205 Market Street
Brookville

MONTGOMERY COUNTY HISTORIC PRESERVATION COMMISSION
STAFF REPORT

| Address: | 205 Market Street, Brookeville | Meeting Date: | 8/12/09 |
| PROPOSAL: | Side addition | | |

Detail: WEST FACADE SHOWING KITCHEN CELL

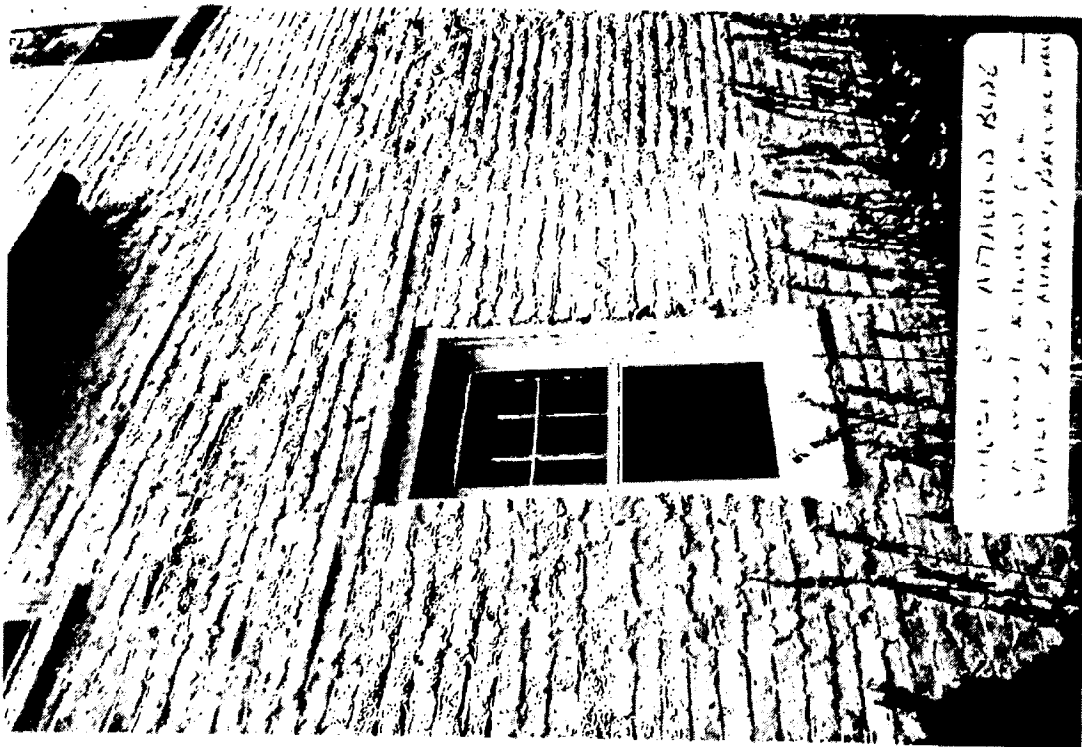
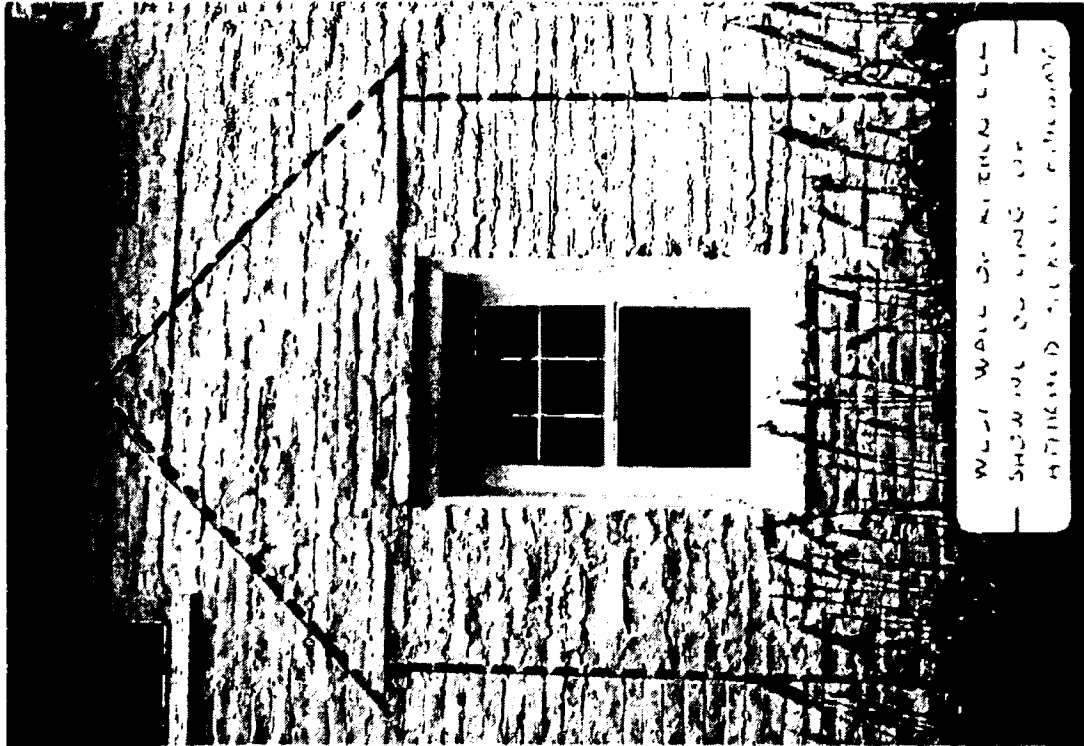
7 MR. ROTENSTEIN: Just since we're asking a few
8 questions and I guess this is probably better directed to
9 the applicant. There appears to be something going on in
10 the brick bond to the right of the area sounding the window.
11 Is that something as well?

6 There was a doorway there, and I do have some
7 photographs from the 1940's that show the doorway. The
8 oldest person who lived there who actually moved into the
9 house in 1930 when he was 10 years old, claims that there
10 was a wood house there, and it was, wood house meaning its
11 function, it was built of brick. It had a dirt floor. The
12 kitchen also had a dirt floor until 1960.

PARTIAL FIRST FLOOR PLAN

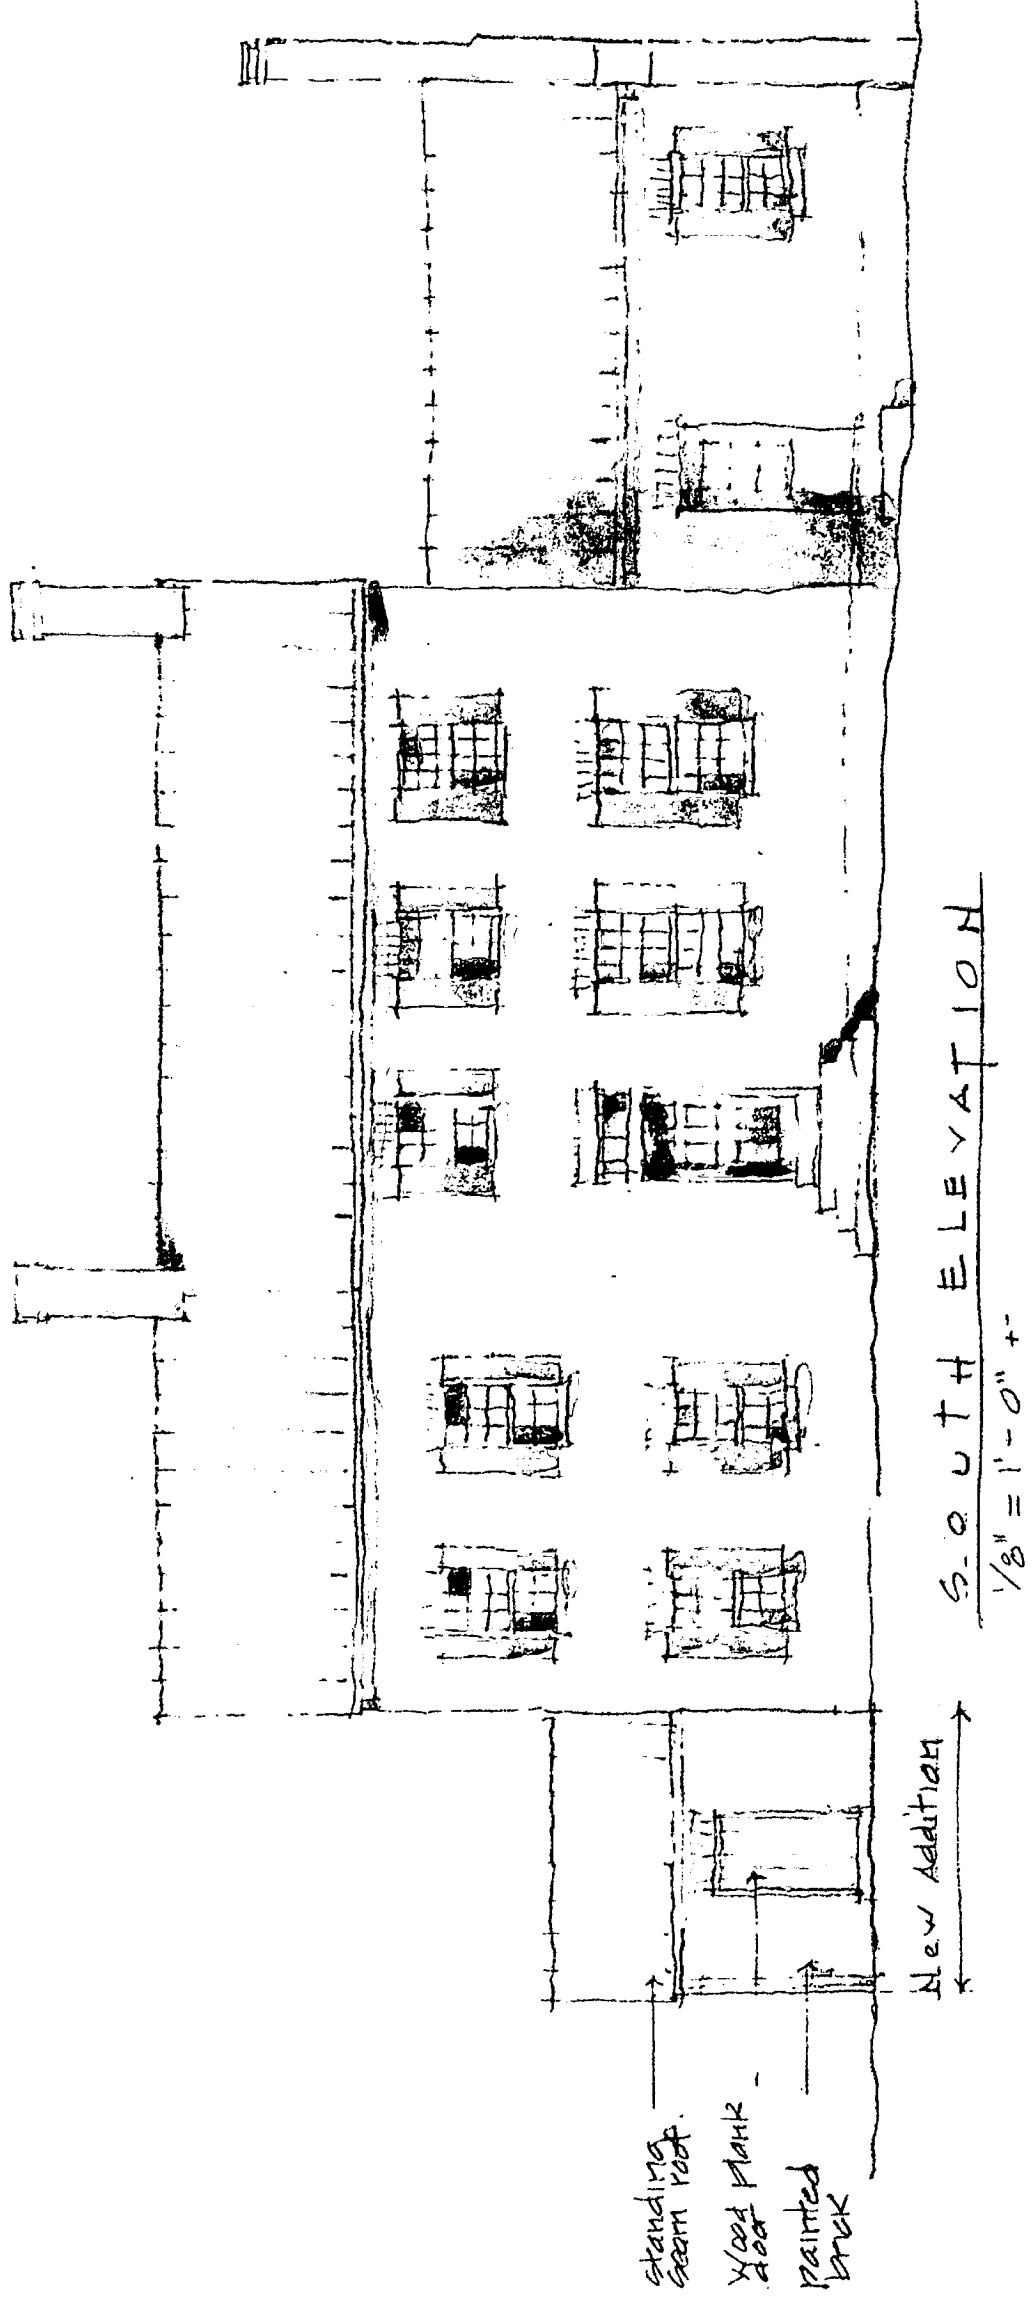
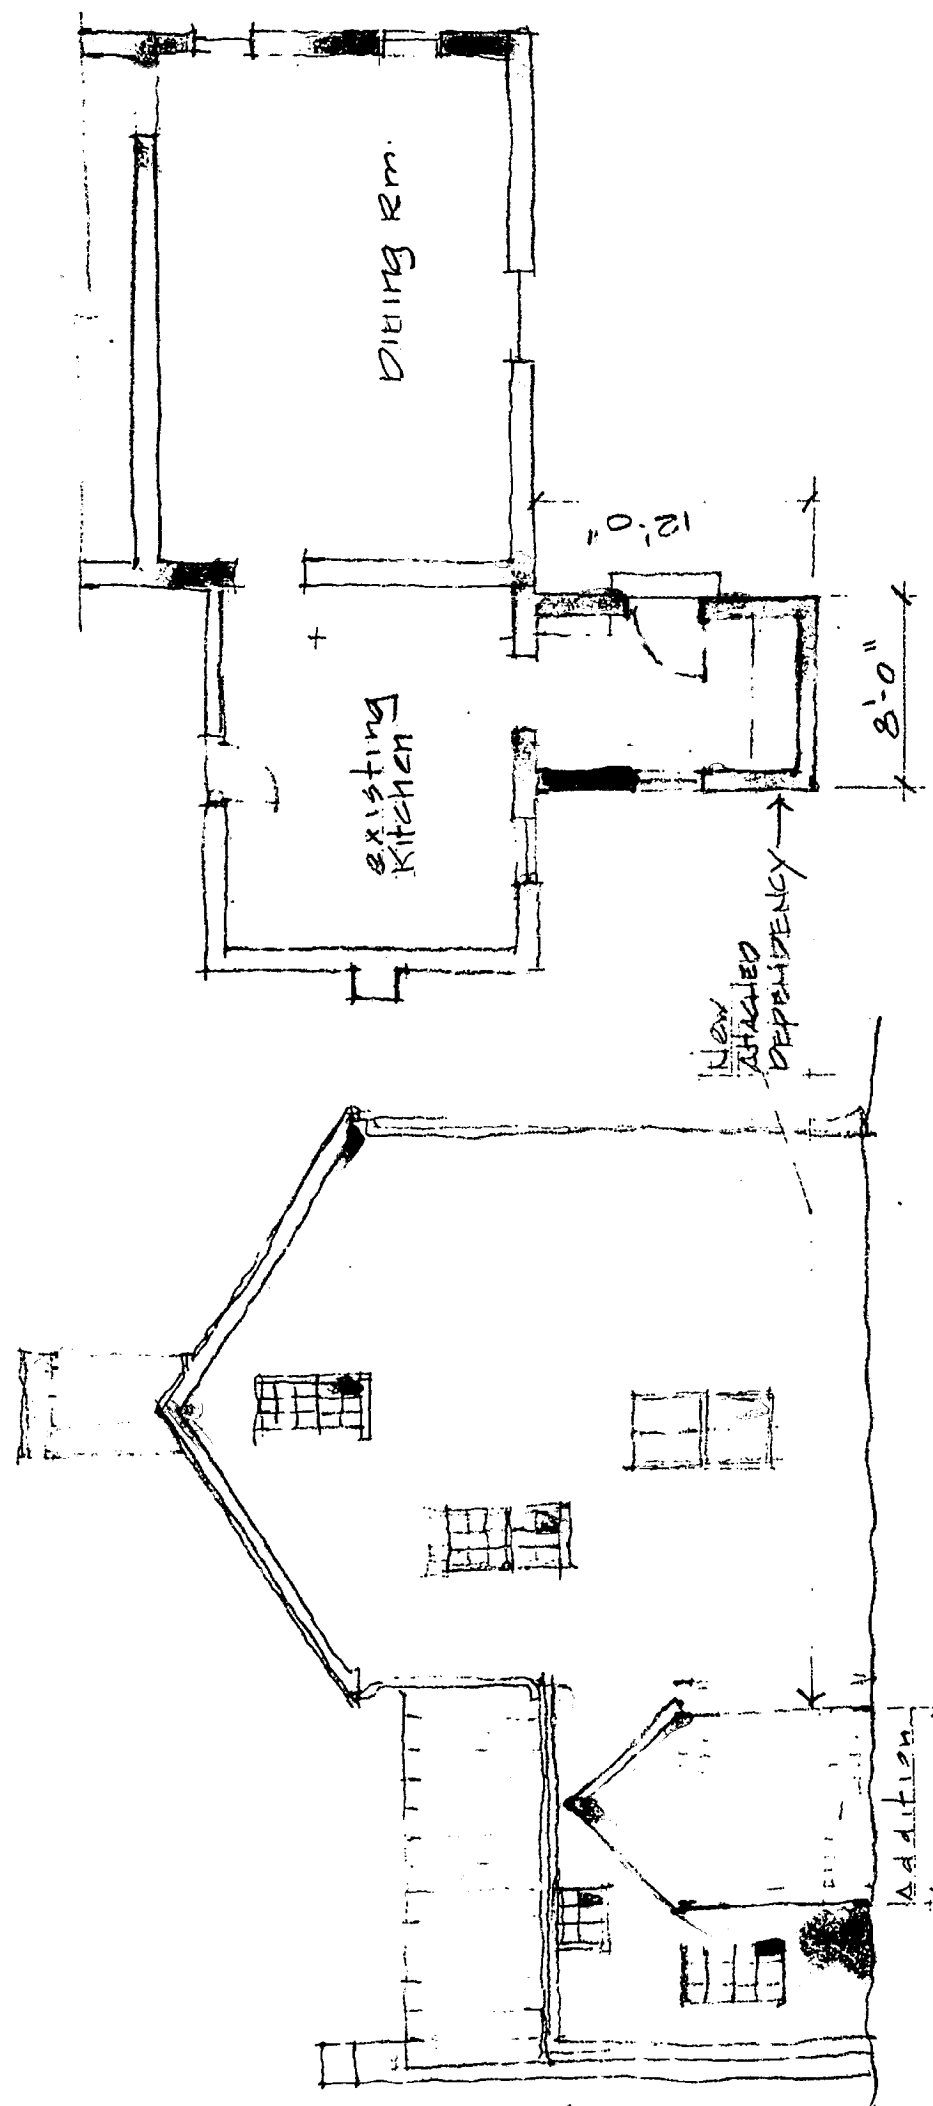
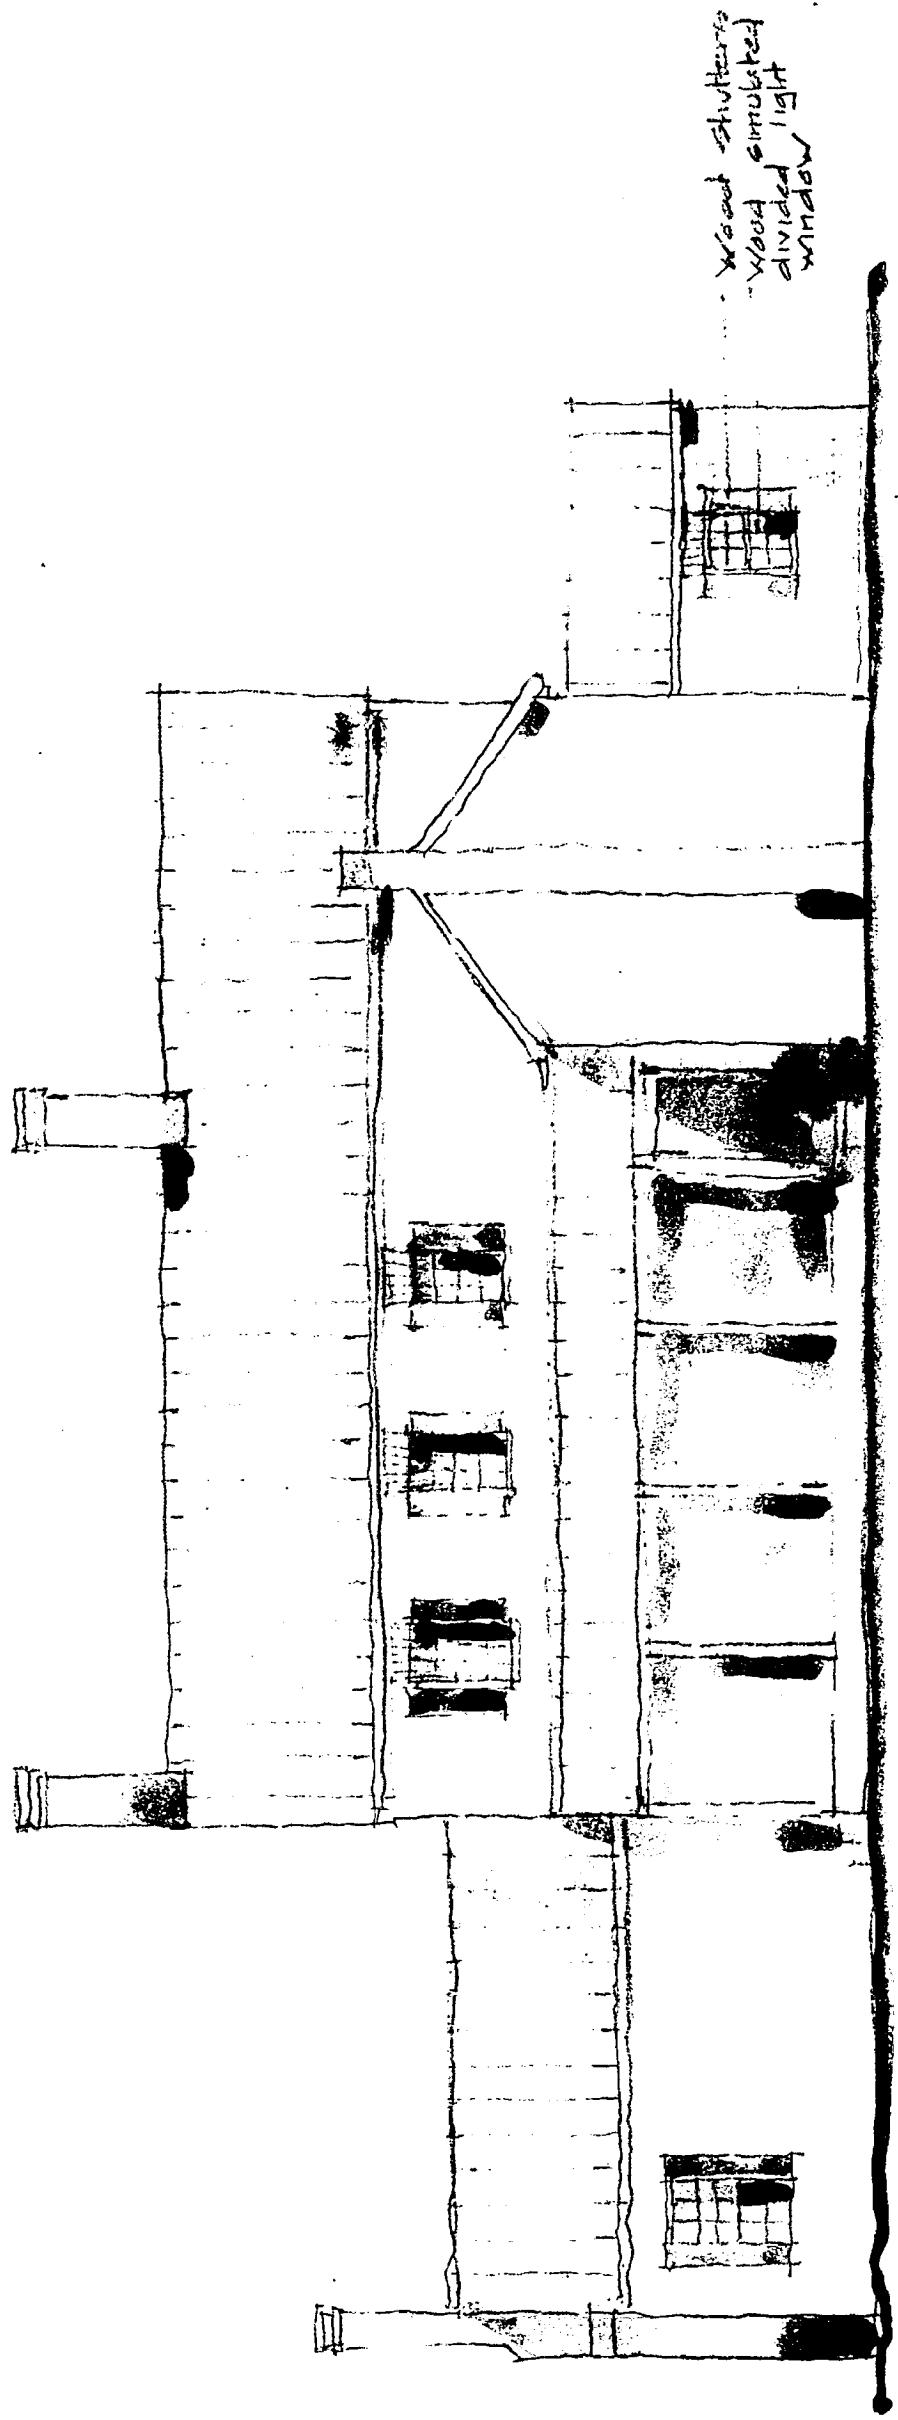
STAFF REPORT SHOULD NOTE DAVID'S FINDING (8')
PLAN PROPOSES 12'

The applicants are proposing to construct an addition at the rear left (west) side of the house extending off an existing kitchen ell. The addition will be 8' wide x 12' long and approximately 14' tall. The proposed materials for the addition are painted brick to match the house, one wood window with simulated divided lights (reused from existing wall), wood shutters and trim, one wood plank door, a standing seam metal roof, and copper gutters. See proposed plans in Circles 17-20.
